### **ALTERATIONS AND ADDITIONS AT 40 SUNRISE ROAD, PALM BEACH STATEMENT OF ENVIRONMENTAL EFFECTS ADDENDUM**

This addendum to the Statement of Environmental Effect is being provided for the modified DA (DA2021/0900) at 40 Sunrise Road, Palm Beach, to assess the environmental impacts of the proposed modifications included in the Section 4.55 application.

*Above; Palm Beach Street View Elevation demonstrating the modulation of the façade provided by the proposed modified lift roof form and external cladding*

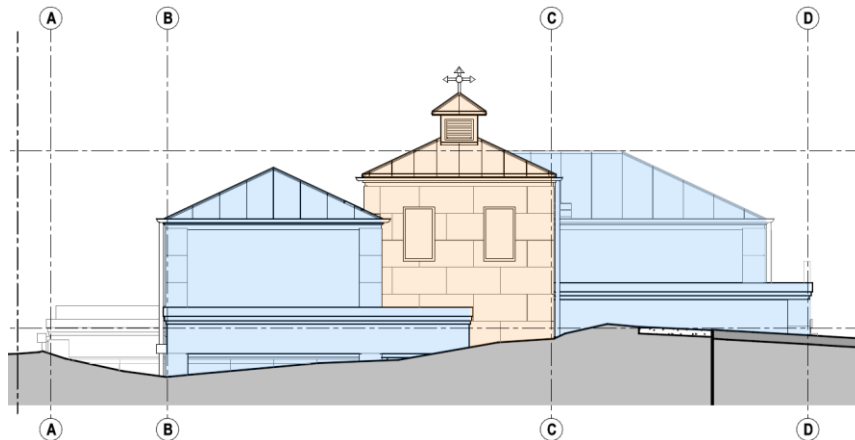
Within the locality of Pittwater, the protection and perception of the bushland as the predominant feature of a site is the key objective of the locality's desired future character. The introduction of the proposed modifications will support this objective by softening density of the dwelling's street facing façade. The proposed modifications which will be visible to the streetscape include changing the approved roof material from slate tiles to copper sheeting, cladding the lift shaft in stone and replacing the flat roof over the lift shaft with a pitched roof. Copper and stone are materials that complement the surrounding bushland and will assist in blending the building form with the surrounding environment. The new articulation proposed to the lift shaft's cladding and roof form will also modulate the dwelling's façade by introducing a material and formal separation between the current massing, thereby reducing the dwelling's visual density. By treating the design of the proposed modifications in this manner, the visual character of the dwelling will remain a subservient feature of the streetscape and recede in comparison to the locality's bushland environment.

Above: 3D Diagram highlighting extent of non-compliance

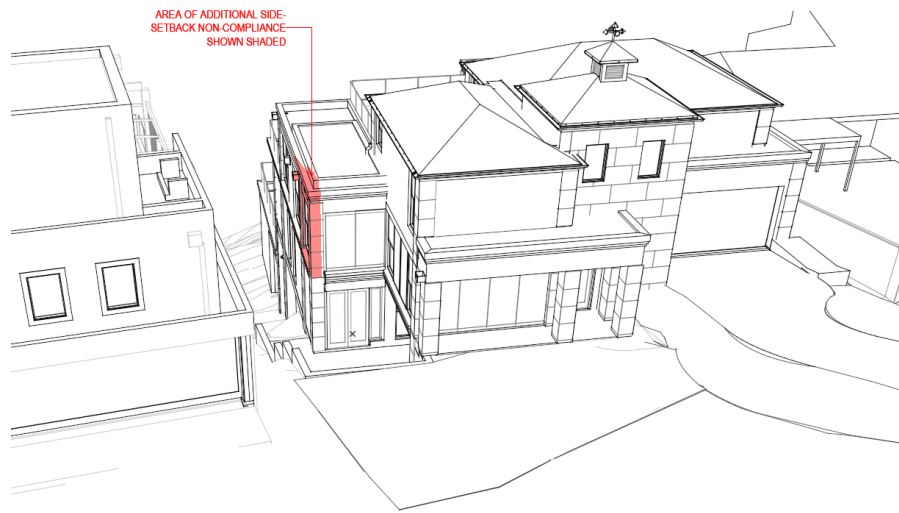
Control	Approved	Proposed Modifications	Compliance
2.5m	2.2m	2.2m @ Enclosed Terrace (UNCHANGED)	AS APPROVED

Although the proposed modification of the enclosed terrace does not comply with the numerical control for the side setback, strict compliance is deemed unreasonable and unnecessary as the proposal maintains the setback of the approval and achieves the objectives of the DCP without impacting on the public or private amenity of the surrounding area.
